Southern Nuclear Operating Company
Vogtle Electric Generating Plant Units 3 and 4
Revised Request for License Amendment Regarding
Reinforced Concrete (RC) to Steel Plate Composite Construction (SC) Connections
(LAR-13-014R3)

Revised Request for License Amendment Regarding
Reinforced Concrete to Steel Plate Composite Construction Connections
(LAR-13-014R3)

The proposed changes would revise the design of connections between reinforced concrete and steel plate concrete composite construction.

UFSAR Subsection 3H, Figure 3H.5-7 - Revise information as shown in the revised figure below.

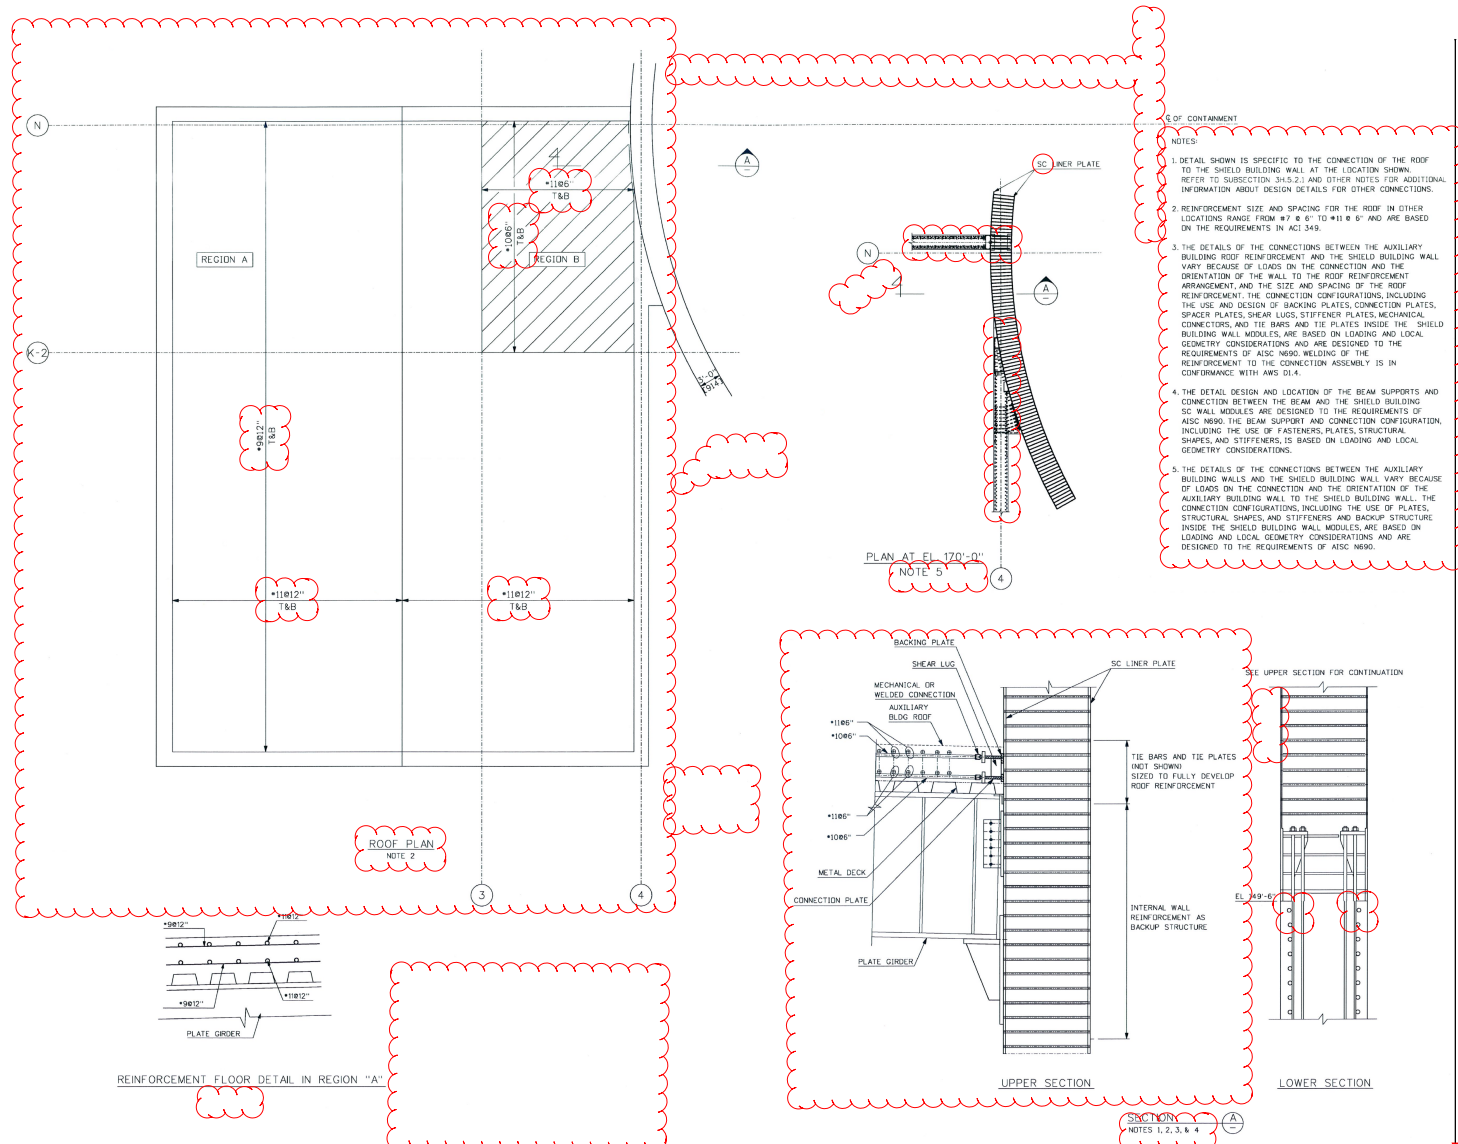
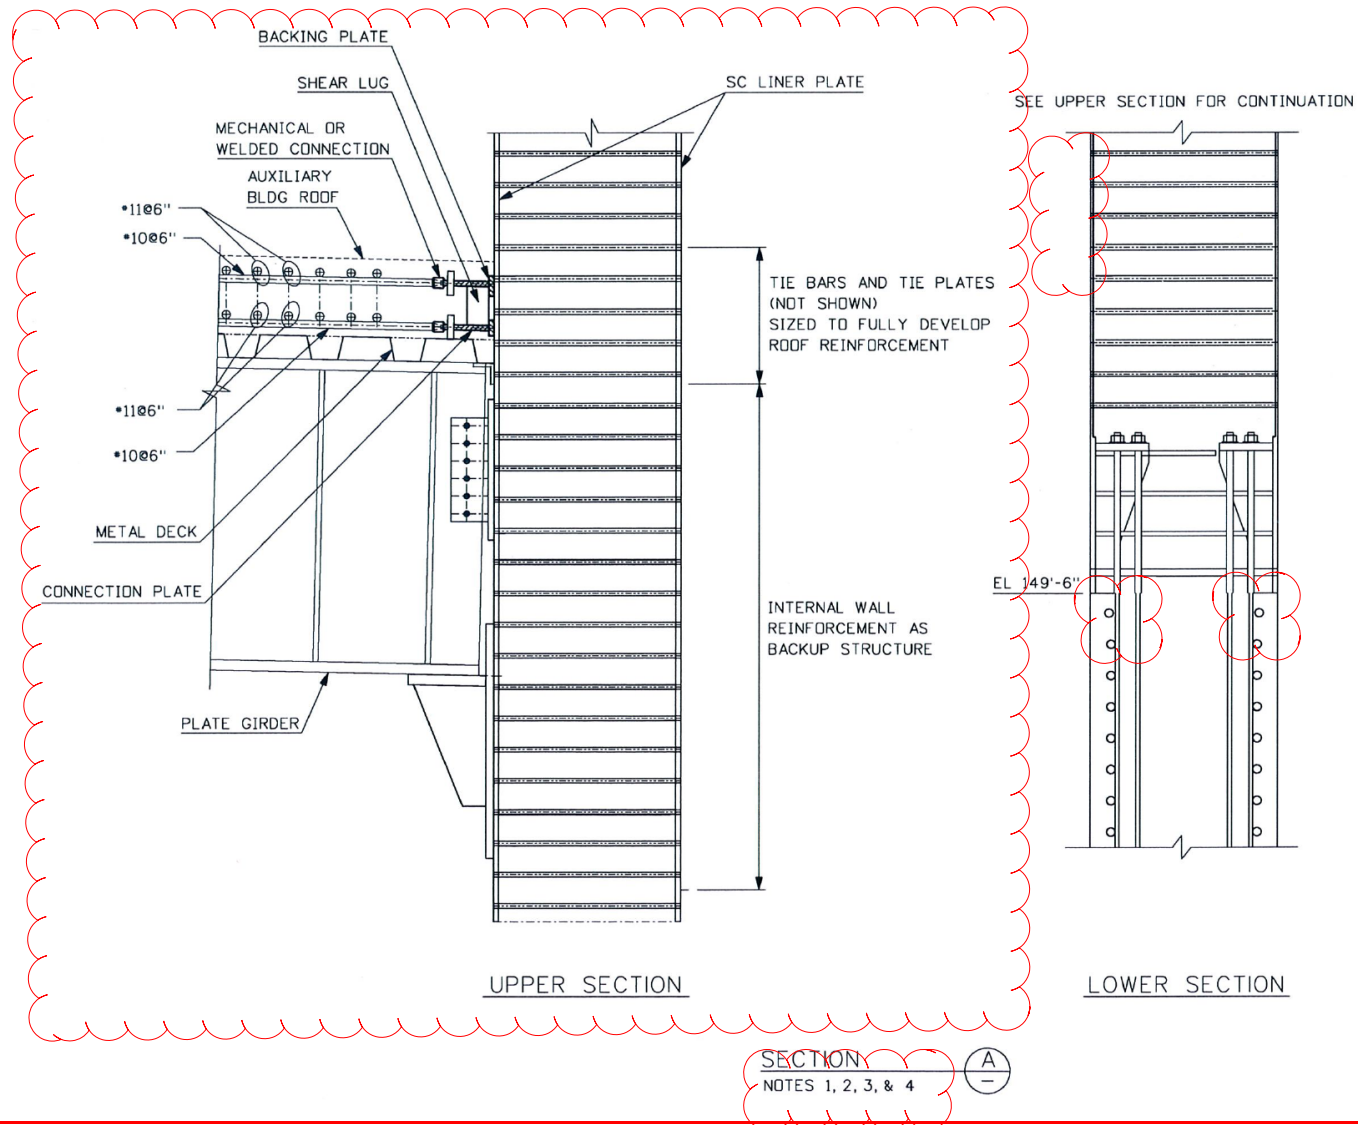
UFSAR Figure 3H.5-7 for the critical section showing the connection of the auxiliary building roof (above the radiologically controlled area of the auxiliary building) to the shield building wall also includes extraneous information unrelated to the critical section and this unrelated information is removed. This information includes the shield building wall radius and thickness and center lines which are shown in Figure 3.7.2-12 Sheet 6. Dimensions of the auxiliary building roof and walls, column lines not needed to define the critical section, distance between column lines, roof elevations, and center lines are removed. This auxiliary building information is shown in Figure 3.7.2-12 Sheets 6 and 7. The representation of the auxiliary building roof reinforcement requirement is changed such that it does not extend into the wall. The drawing scales are not appropriate and are proposed to be removed from the roof plan, the Reinforcement Floor Details in Region A, and Section A showing the connections in the roof since UFSAR figures are not to scale. The roof details provided for Region B are proposed to be removed since information for this portion of the roof is duplicated in Section A of Figure 3H.5-7. The auxiliary building Wall 4 and Wall N connection details (identified as PLAN AT EL. 170'-0") are revised. The information revised is the detail design of connections of auxiliary building wall to the shield building wall and these wall detail designs are not part of the connection of the roof to the shield building wall and are not part of the roof connection critical section. Notes are added to the figure to describe the variances in the connection detail designs.

Revise the information in UFSAR Figure 3H.5-7 as follows:

1. The Upper Section in the Section A detail showing an elevation of the roof to wall module connection information is revised to reflect changes to the connection of the roof to the wall including change in the design of the shear lug, addition of a connection plate for connection of roof reinforcement to structural modules, the addition of a stiffener plate, the addition of an connecting plate welded to the module faceplate, and the

change in the design of the connection of the girder to the wall. The extension of roof reinforcement into the wall is removed and tie bars in the wall module are designated as internal wall reinforcement to develop roof reinforcement and provide backup structure for the roof girder connection.

2. Extraneous information is removed from the roof plan including the shield building wall radius and thickness, dimensions of the roof and walls, column lines not needed to define the critical section, distance between column lines, roof elevations, and center lines and the information removed from UFSAR Figure 3H.5-7 is provided in UFSAR Figure 3.7.2-12 and Subsection 3H.5.2.2. The representation of the roof reinforcement requirement is changed to not extend into the wall. The N (North) direction indicator is removed from the upper right portion of the figure.

4. The drawing scale is removed from the Roof Plan because UFSAR figures are not to scale. The scale is not relevant to the critical section addressed in UFSAR Subsection 3H.5.2.1 and this figure and UFSAR figures are not to scale.

6. The REINFORCEMENT FLOOR DETAIL IN REGION "B" is removed since it is duplicate information to the Tier 2* information details shown in SECTION A.
7. The tie bar spacing is removed from the Lower Section in Section A. This information is available in APP-GW-GLR-602, Figure 6.

**Figure 7, Typical Auxiliary building RC roof connection to the shield building SC wall -
Revise the figure as shown below.**

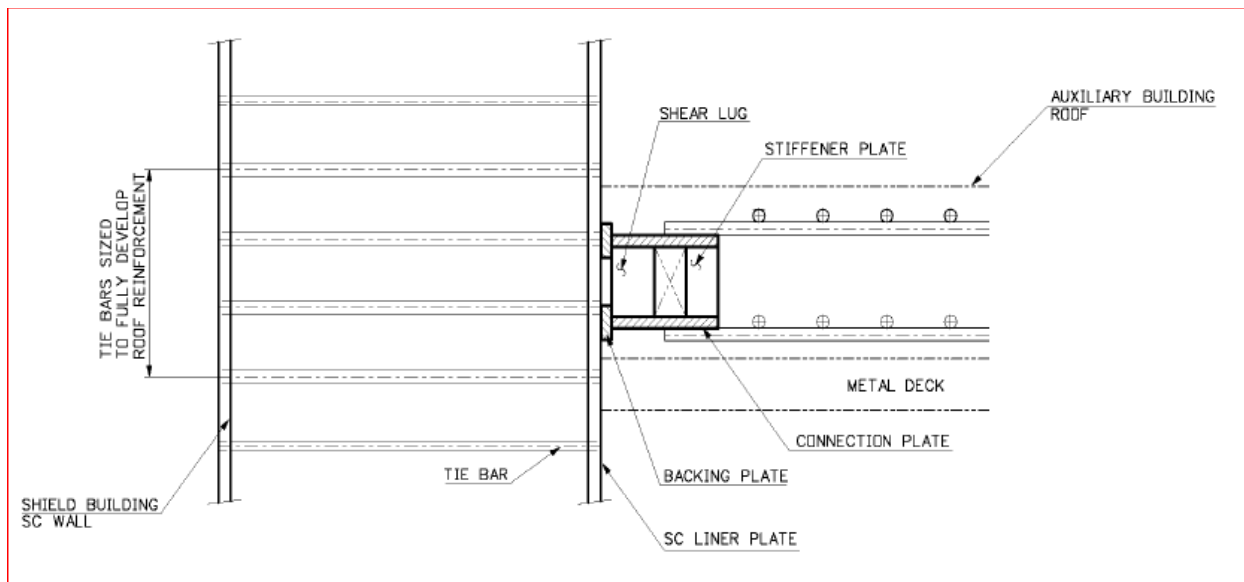
The revised auxiliary building roof connection design eliminates the separate radial bars extending into the roof concrete from the wall and directly connects the roof reinforcement to the wall module. A typical connection design is shown in the revised Figure 7 of APP-GW-GLR-602. This design detail is from a different location and is different than the location shown and the configuration shown for the critical section in Figure 3H.5-7. The details of the connections between the auxiliary building roof and the shield building wall vary because of loads on the connection and the orientation of the wall to the roof reinforcement arrangement. The design of the connection is described below. Connection variations use different combinations of the design elements described.

Connection plates, which provide connections to the top and bottom roof reinforcement, are welded to built-up backing plates on the outer faceplate of the shield building wall. The

faceplates are identified as SC Liner Plate in Figure 7 of APP-GW-GLR-602 and UFSAR Figure 3H.5-7. The roof reinforcement bars are welded to the connection plates, or to additional plates welded to the connection plates, using a flare bevel weld in conformance with AWS D1.4. The welded connection fully develops 125% of the specified yield strength of the reinforcement bars. The additional plates are used as spacers when the elevation of the reinforcement is offset from the top surface of the connection plate by other reinforcement. In some locations mechanical connectors welded to front plates perpendicular to the connection plate are used to connect the reinforcement bars to the connection assembly. This configuration of the mechanical connectors welded to the front plates which are welded to the connection plate is shown as part of a critical section in Section A of the revised UFSAR Figure 3H.5-7. The connection design includes radial shear lugs adjacent to the faceplates between the connection plates for the upper and lower layers of reinforcement. Stiffener plates between the upper and lower connection plates on the outer edge of the connection assembly provide additional rigidity to the connection assembly when needed and act as additional shear lugs.

Figure 7 of APP-GW-GLR-602 showing a typical connection design for the auxiliary building roof to the shield building wall, incorporated by reference into the UFSAR, is proposed to be updated to incorporate the auxiliary building roof to shield building connection design changes described above. Notes on the figure are revised to include design requirements and design basis instead of specific reinforcement size and spacing. A note is added to reference to UFSAR Subsection 3.8.4.5.5.6.

Revise Figure 7 to show a revised connection design including:

1. The connection inside the shield building wall is provided by through wall tie bars sized to fully develop the Auxiliary Building Roof a range of reinforcement. ~~Spacing is determined along the shield building wall.~~

Figure 7 Typical Auxiliary building RC roof connection to the shield building SC wall

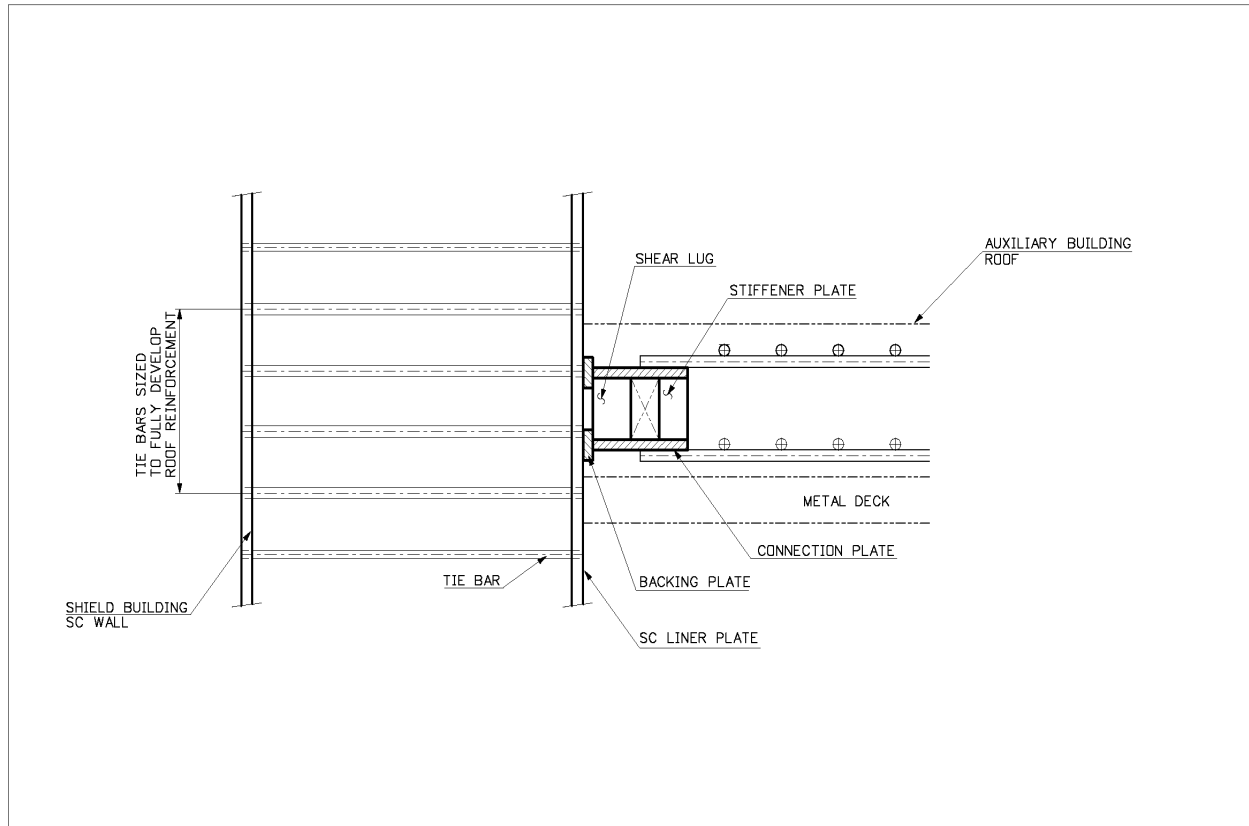
Figure 7 shows the typical details for the connections between the RC auxiliary building roof and the SC Shield building wall. The details of the connections between the auxiliary building roof and the shield building wall vary at some locations from those shown in the figure because of loads on the connection and the orientation of the wall to the roof reinforcement grid. The design variations include the use of spacers or other design elements to accommodate the offset in the elevation for different layers of reinforcement. The variations also include the use of mechanical couplers connected to the vertical surface of design elements. The several different configurations have the roof reinforcement directly connected by welding or mechanical connectors to a connector plate that is welded to shield building wall faceplate or to connector plates built up on the faceplate. The design and construction of the connection within the reinforced concrete roof is governed by ACI-349 and by AISC N690 for

1. The connection inside the shield building wall is provided by through wall tie bars sized to fully develop the Auxiliary Building Roof reinforcement.
